GREATER GEELONG PLANNING SCHEME

AMENDMENT C360

**GREATER GEELONG PLANNING SCHEME
DELEGATED AUTHORITY REPORT
AMENDMENT C360
CONSIDERATION OF SUBMISSIONS**

To: Peter Bettess – General Manager Planning & Development
From: Urban Growth
Subject: Consideration of submissions
File number: Proposed Planning Scheme Amendment to apply a Public Acquisition Overlay on land at 661-669 Barwon Heads Road and 619-639, 641-655 and 657-669 Boundary Road, Charlemont.
Date of Report: 25 May 2017

Appendix 4 – Proposed PAO

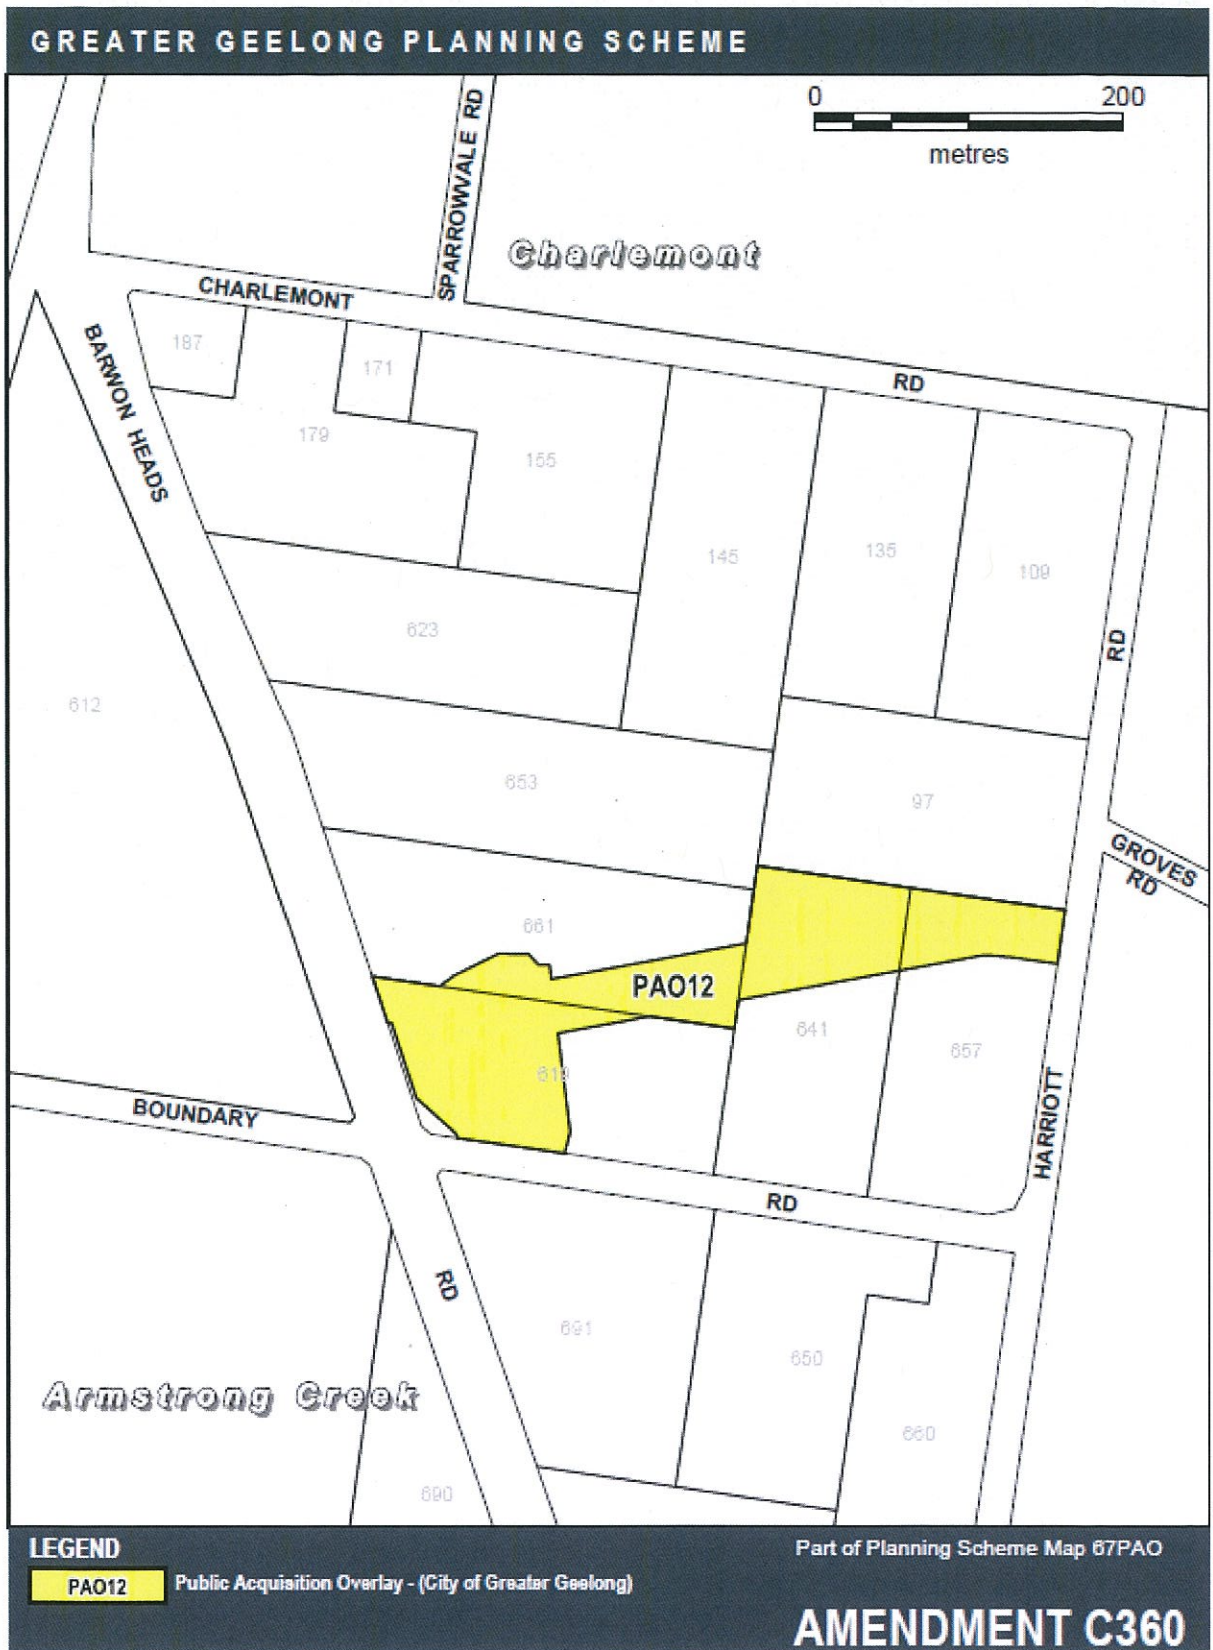
Sub. No.	Name	Status	Ref.	Issues	Response	Discussion	Document changes required
4	EPA Victoria	No objection	4.1	EPA have no objection to the proposed PS Amendment	Noted.		
5	S. O'Hara	Objection	5.1	Would prefer to see the drainage placed underground with the creation of easements extending across the submitters boundary.	<p>The drainage design and associated cost of land acquisition and construction is based on an above ground swale drain. There are a number of reasons why an open swale is proposed including existing topography, sustainability to carry flows, aesthetics and landscaping, which include a proposed shared path all of which is consistent with the outcomes sought by the PSP.</p> <p>The Horseshoe Bend Precinct Stormwater Management Strategy (Oct 2013) also confirms 'the intent is to establish a "naturalised" waterway environment which is capable of evolving with time as vegetation communities become established under the changing hydrologic regime associated with catchment urbanisation'. At page 35 of the Strategy, the key design objectives are as follows in no specific order of priority:</p> <ul style="list-style-type: none"> • Channel stability and sustainable capacity to carry flows, • maintainability (gentle batters and access trails where mowing is needed), • accessibility and safety (again resolved to gentle batter slopes especially where free public access is available, plus low velocities), • landscape appeal (diversity of batter slopes and plantings and pools/runs/riffles plus some open views), • environmental values (sediment control, plantings and habitat diversity-pools/runs/riffles),

Sub. No.	Name	Status	Ref.	Issues	Response	Discussion	Document changes required
			5.2	Underground drainage is consistent with the rest of the drainage and the cost could be recovered from developers and will cause the least disruption of their property.	It is true that an underground drain would cause less disruption to the use of the property however open drains are both common in the growth area and appropriate for the reasons outlined above. The Horseshoe Bend PSP proposed an above ground water course and the DCP is costed on that basis.

5.3	The diagonal alignment is a major concern and will result in an unnecessary loss of amenity. Ideally, the acquisition area should be squared off in a manner so that the southern boundary line of the acquisition area is moved further north creating a smaller area of acquisition and leave a regular rectangle for the remaining property.	The alignment of the PAO boundary extends diagonally across the submitters land. The alignment of the PAO has been determined as a result of preliminary engineering plans however recent discussions between officers from Urban Growth and Council's Engineering Unit has revealed that it may be possible to move the boundary north as suggested by the submitter. These discussions remain ongoing and at this stage the alignment remains unchanged. Another matter which will also need to be considered is the area set aside under the DCP and it will be important to ensure the PAO area is not increased should the alignment be altered.

5.4	A solution could be a meandering stream which could be accommodated in a changed acquisition area in the northern aspect of the submitter's property.	Recent discussions between officers from Urban Growth and Council's Engineering Unit has revealed that it may be possible to move the boundary north as suggested by the submitter. These discussions remain ongoing and at this stage the alignment remains unchanged. The Horseshoe Bend Precinct Stormwater Management Strategy (Oct 2013) also confirms at page 35, "the open waterways proposed to be constructed within the HBP are shown as straight lines...The design intent for future subdivisional design however is for every opportunity to be taken to meander the section through urban areas."

Sub. No.	Name	Status	Ref.	Issues	Response	Discussion	Document changes required
			7.3	Request to reconsider alternative location. or as an alternative, the extent of the PAO be reduced (refer to attached mark up plan showing reduced area)	The alignment of the PAO has been determined as a result of preliminary engineering plans and the Horseshoe Bend Precinct Stormwater Management Strategy (Oct 2013) however recent discussions between officers from Urban Growth and Council's Engineering Unit has revealed that it may be possible to move the north eastern section further north as suggested by the submitter. These discussions remain ongoing and at this stage the alignment remains unchanged. Another matter which will also need to be considered is the area set aside under the DCP and it will be important to ensure the PAO area is not increased should the alignment be altered.		
8	Department of Environment, Land, Water and Planning	No objection	8.1	Together, the stormwater management arrangements that are proposed for the land which is the subject of this amendment and C357 will provide a positive and effective response to past DELWP advocacy in respect of stormwater drainage impacts from Armstrong Creek Growth Area precincts on the Ramsar listed Lake Connewarre complex.	Noted.
